ARB Staff Report

ARB2020-10071

Requested Action

500 N. Orange Ave. AT&T/WSSA Building Renovation and New Garage

OVERALL EXTERIOR ELEVATION - SOUTH

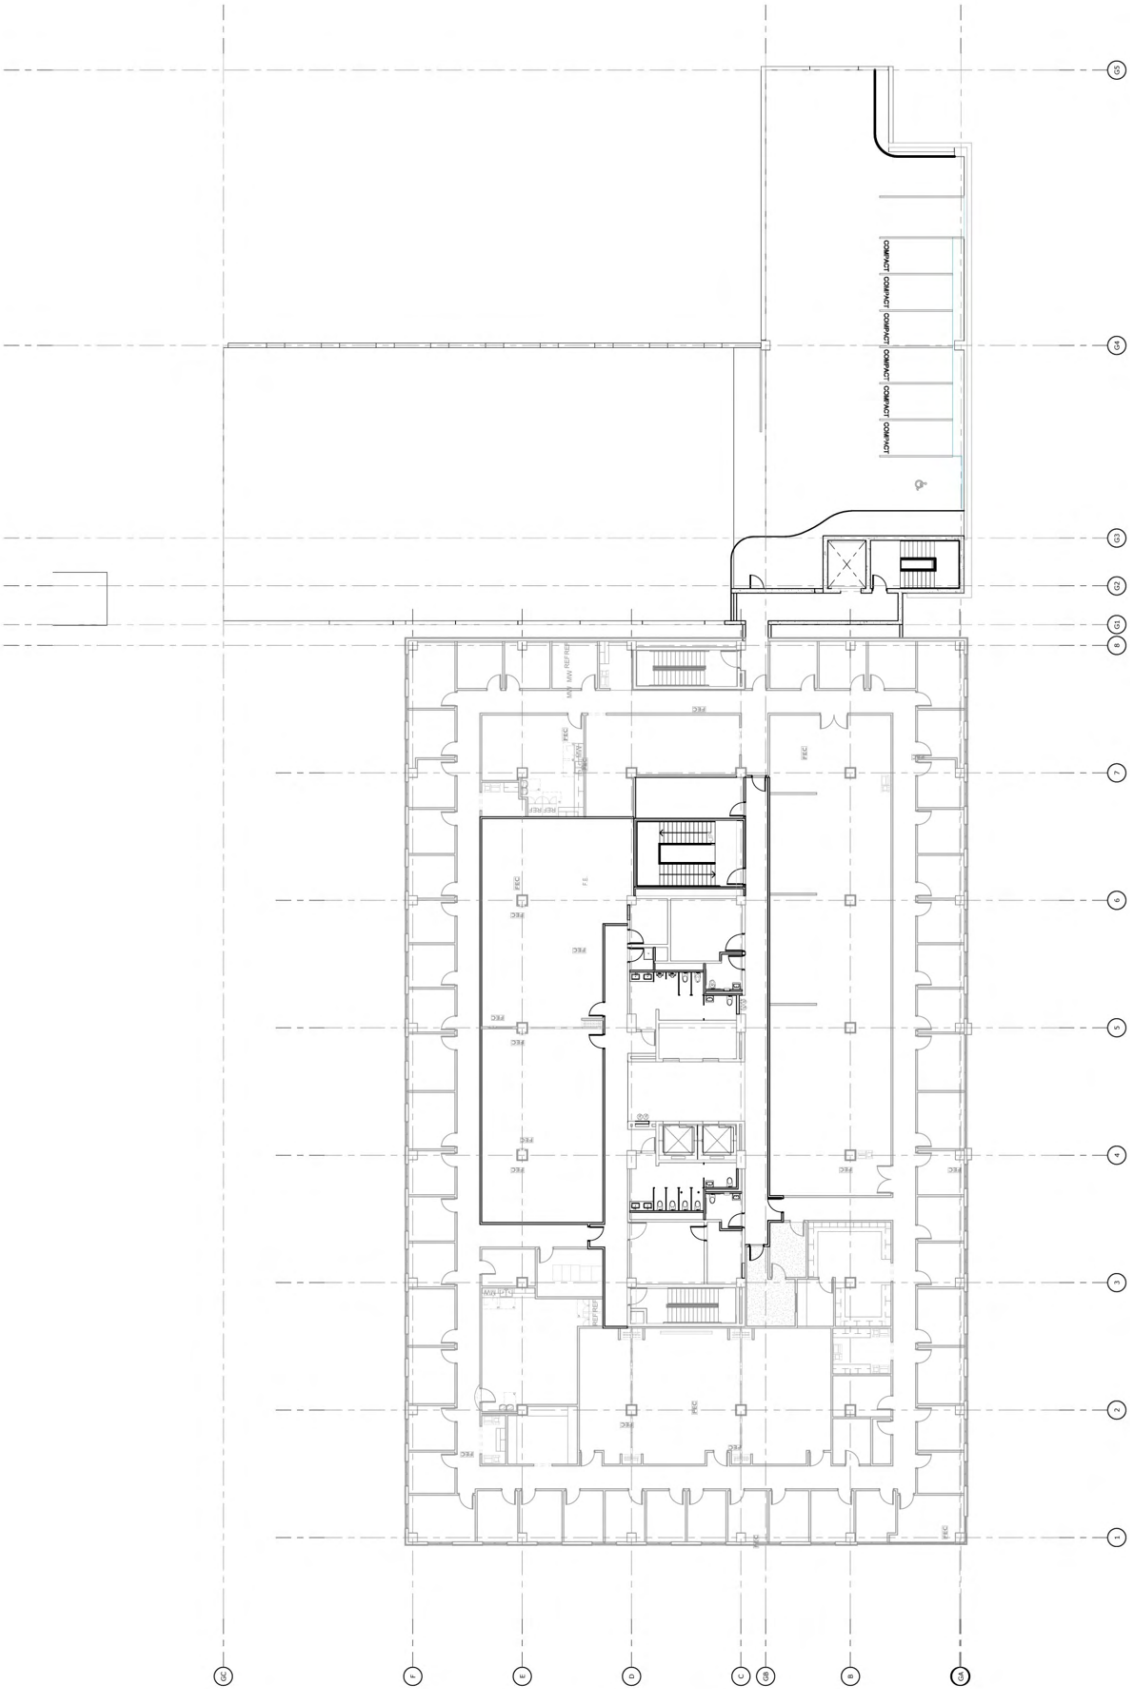
The proposal shows blue glass for the ground floor and transparency may be an issue as ground floor glass is required to be clear.
